Residential-led Mixed-Use Development at Sandford Road, Milltown

Preliminary Design Stage Quality Audit

190226-X-90-X-XXX-RP-DBFL-CE-0004

4.2.3 Location (S3) – Toucan Crossing

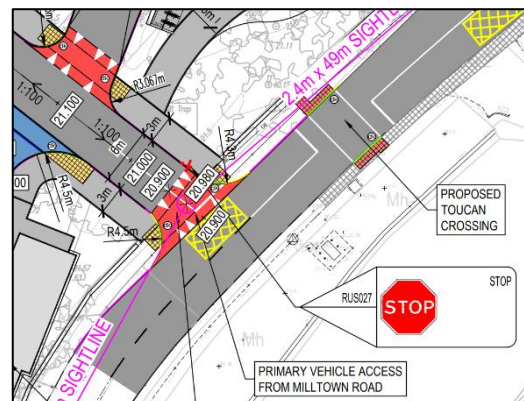
A toucan crossing is proposed to the north of the western site access. No transitions for cyclists are provided, and the footpath appears to be pedestrian only. A lack of transitions may cause cyclists to wait in the carriageway to cross at the toucan crossing, where they may be struck by vehicles.

It is recommended that transitions for cyclists should be provided at the toucan crossing, and that any shared areas should be marked as such, with appropriate tactile paving.

Appendix A : Problem Location Map

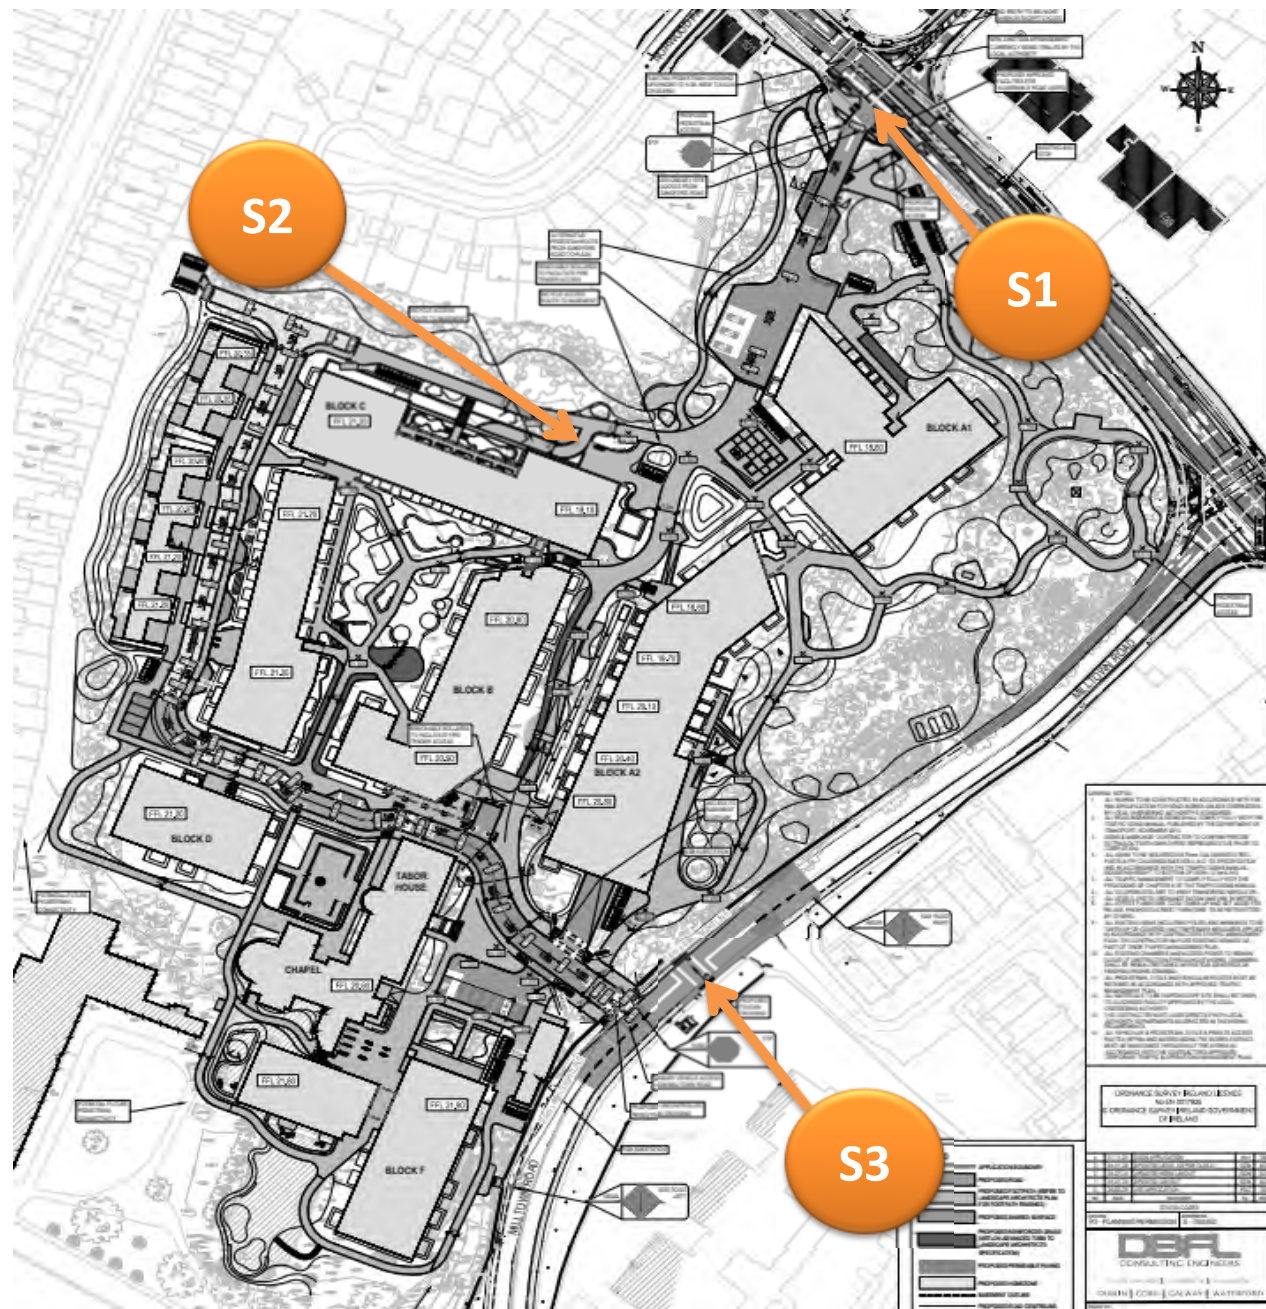
A bicycle access route to the basement is provided. It is unclear if this bicycle only route will have a colour contrast or pavement texture different to the pedestrian routes to distinguish it as cyclists only. A lack of contrast could lead to pedestrians using the route resulting in potential collisions.

It is recommended that colour contrasting materials along with suitable road markings and signage should be provided for cyclist-only routes and shared-use routes, and that they should be suitably wide to cater for both cyclists and pedestrians.
